RE: ELIGIBILITY OF DEEPROOT SILVA CELLS FOR CITY OF VICTORIA RAINWATER REWARDS

RE: Silva Cell System: St. Louis MSD Submission

RE: Silva Cells for Stormwater Runoff Filtration

<p>BIORETENTION WITH INTERNAL WATER STORAGE IN SOIL CELLS FOR RETROFIT</p> <p>TYPICAL SECTION</p>	<p>DEEPROOT GREEN INFRASTRUCTURE Non-Standard Details of Sewer Construction</p> <p>AUGUST 2013 DETAIL 5A-1</p>

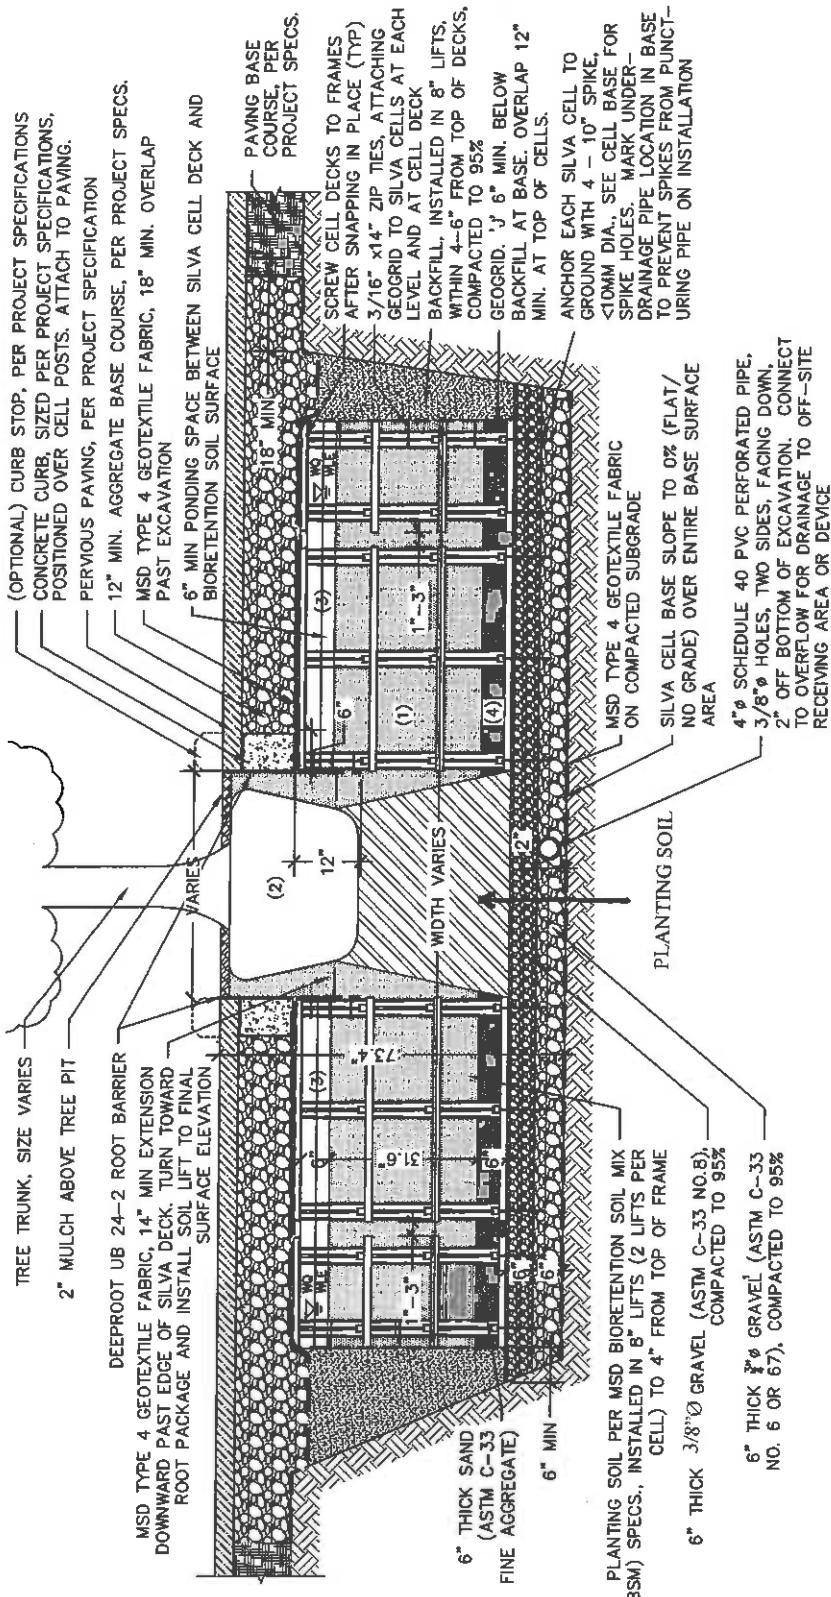
- The Silva Cell shall be designed and applied in accordance with the details attached to this letter. When supplemented with permeable pavement, the permeable pavement may manage a larger upstream tributary area (up to a ratio of 4:1) as a stand-alone BMP, regardless of the saturated hydraulic conductivity of the underlying soil.
